UNITED STATES PATENT AND TRADEMARK OFFICE

10/589,499

Guy N. Pearson

Office Action Summary	Application No. 10/589,499	Applicant(s) PEARSON ET AL.	
	Examiner JONATHAN M. HANSEN	Art Unit 2886

FIG. 4

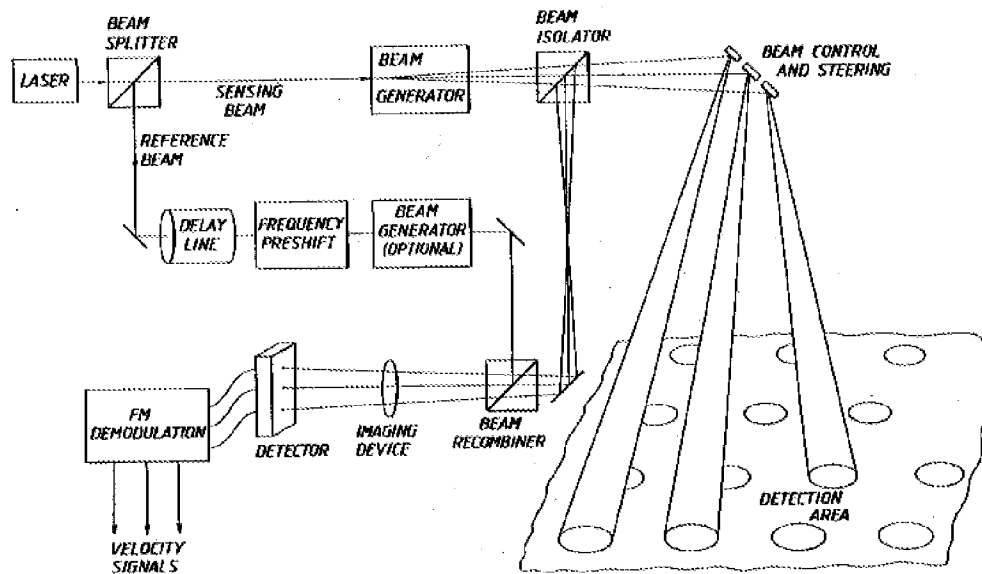
In regards to claim **1**, Berni discloses and shows in Figure 4 below, a laser vibrometer comprising:

a frequency modulated laser source for producing a sensing beam (applicant's transmit beam) and a reference beam (applicant's local oscillator signal), both having the same frequency modulation (col. 7, ll. 36-49);

means for directing the transmit beam to a scene and receiving radiation reflected from the scene (col. 17, ll. 43-68);

a beam recombiner (applicant's mixing means) for mixing the received radiation with the local oscillator signal (col. 18, ll. 1-3); and

a detector for detecting frequency variations between the received and local oscillator signals (col. 18, ll. 10-13);

wherein the vibrometer further comprises an optical delay for delaying the local oscillator for substantially the flight time of the received radiation (col. 8, ll. 60 to col. 9, ll. 11).

In regards to claim **12**, Berni discloses a laser vibrometer wherein the means for directing the transmit beam to a scene and receiving radiation reflected from the scene transmits and receives radiation from a plurality of look directions (Figure 4).
